THE SHOPS AT
PIPER GLEN

ALTERNATE SITE PLAN

SUBJECT: Administrative Change to Specific Plans for Parcel #4
of Petition No. 86-4(c)

SUBJECT: Administrative Approval to Specific Landscape Plan for Parcel #4 at
Piper Glen, Part of Petition No. 86-44(c), Tax Parcel No. 225-061-01,
225-011-03, 07, 225-021-01, 225-031-01, 225-041-01, 225-051-01.

SITE PLAN
SCALE 1"=40'-0"

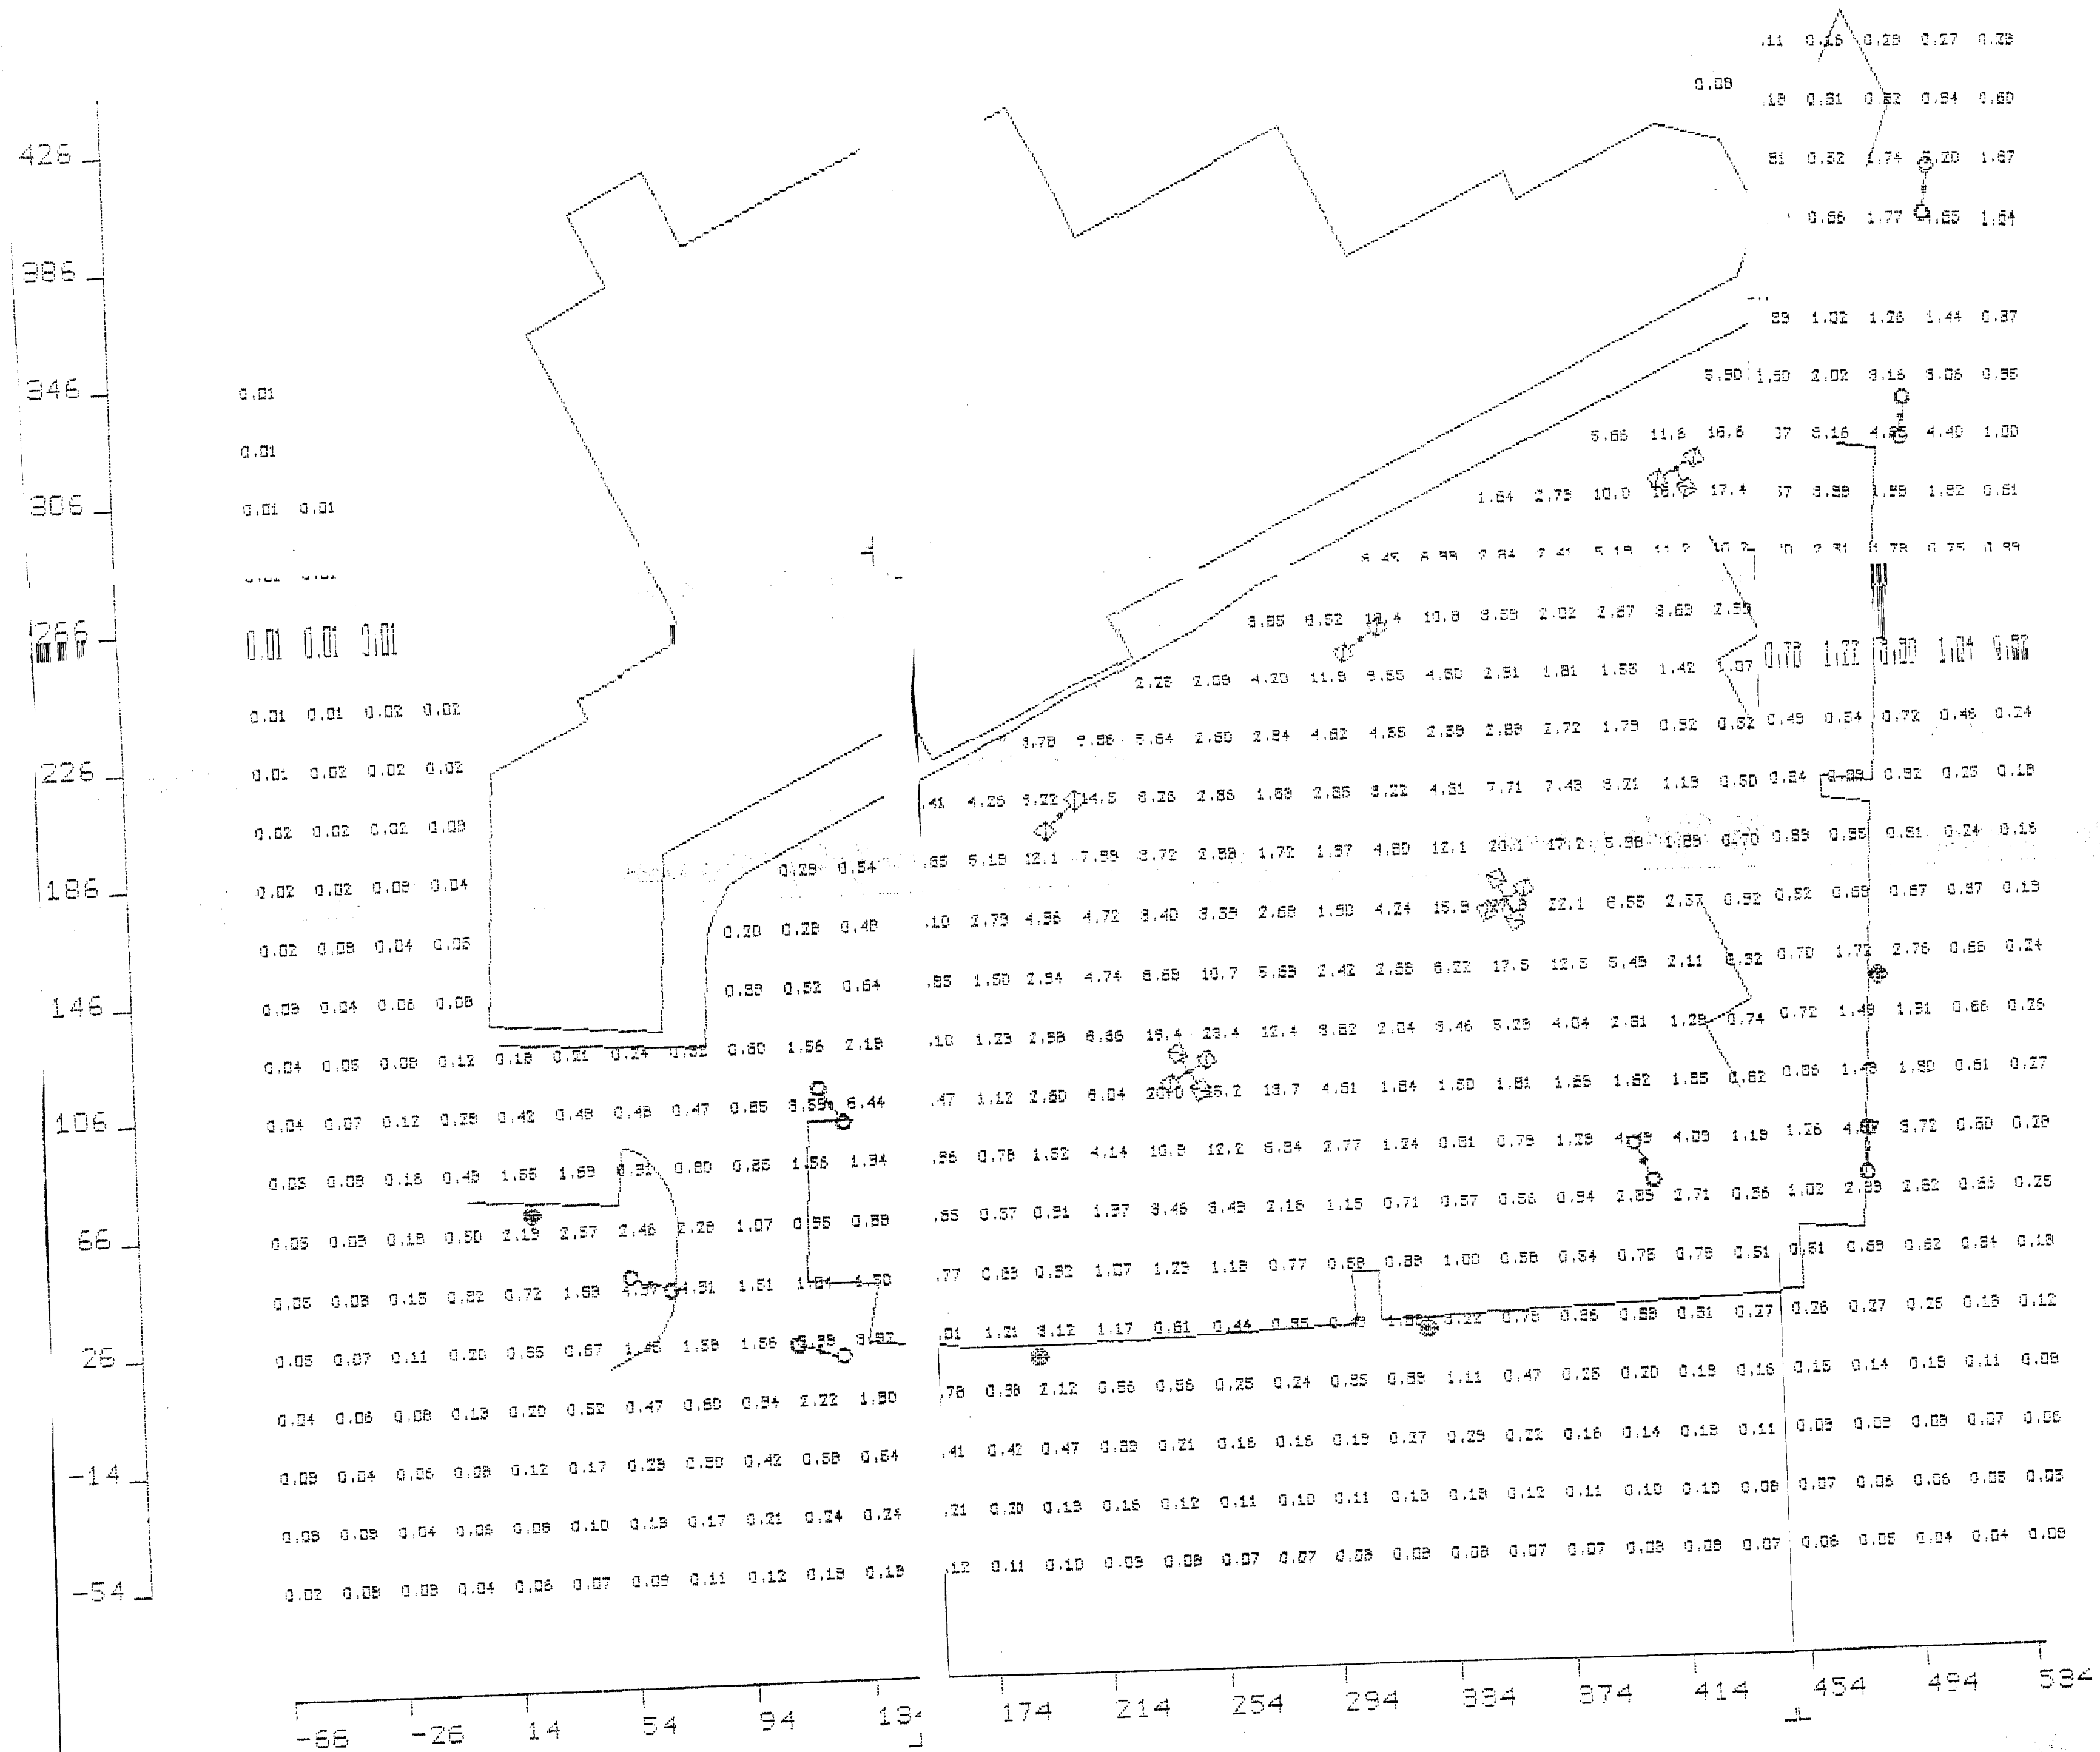
Attached is a revised site plan for the above mentioned rezoning petition this revised site plan demonstrates how the lighting for the shopping center is been revised to add five new lighting fixtures. These new fixtures will replace five existing fixtures. The existing fixtures will be placed at the perimeter of the site. We have looked at the effect these new lights will have on the adjoining properties and are satisfied that the effect will be negligible. Therefore we are administratively approving the addition of these light fixtures. Please use this plan when evaluating requests for building permits and certificates of occupancy.

If the new light poles displace any existing vegetation it must be replaced.
